CONSTRUCTION PLAN

DELAWARE DEPARTMENT OF TRANSPORTATION	ADDENDUMS / REVISIONS	SCALE 0 30 60 90 FEET	I-95 & US 202 INTERCHANGE	CONTRACT T200510602	BRIDGE NO. NA	CONSTRUCTION DETAILS CD 3 OF 14	SHEET NO. 157
	△2 REVISED DETAIL TITLE AND NOTE			COUNTY NEW CASTLE	DESIGNED BY: TM		TOTAL SHTS. 482
					CHECKED BY: MAA

DELAWARE DEPARTMENT OF TRANSPORTATION	ADDENDUMS / REVISIONS	SCALE 0 30 60 90 FEET	I-95 & US 202 INTERCHANGE	CONTRACT T200510602	BRIDGE NO. NA	CONSTRUCTION DETAILS CD 4 OF 14	SHEET NO. 158
	△ REVISED DETAIL TITLE			COUNTY NEW CASTLE	DESIGNED BY: TM		TOTAL SHTS. 482
					CHECKED BY: MAA

* FROM STATION 40+30.51 TO STATION 42+00

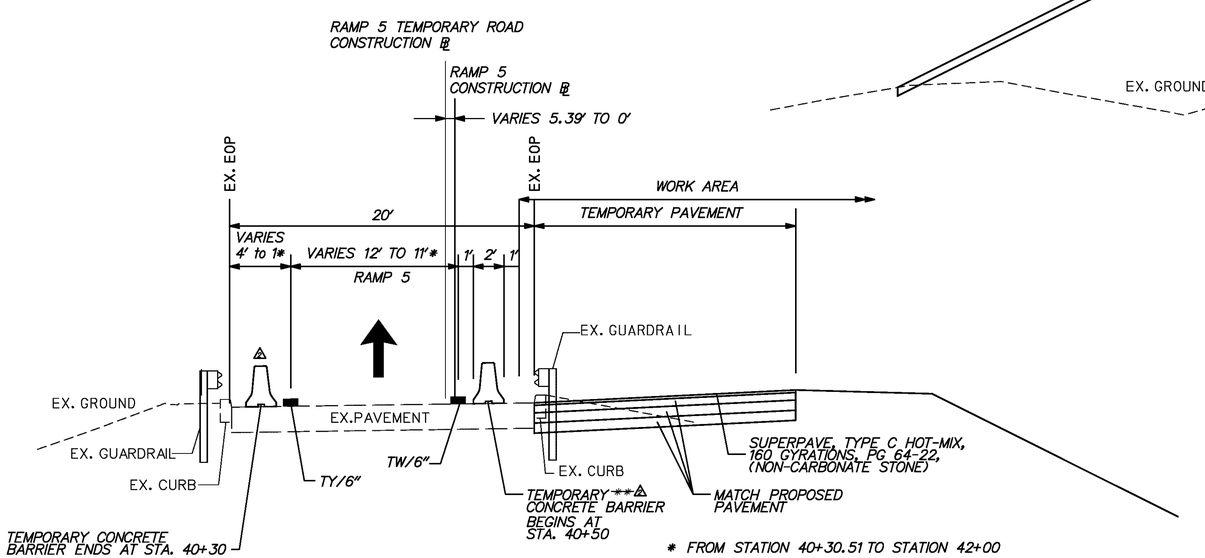
~~** TEMPORARY CONCRETE BARRIER ENDS AT STA 45+60~~
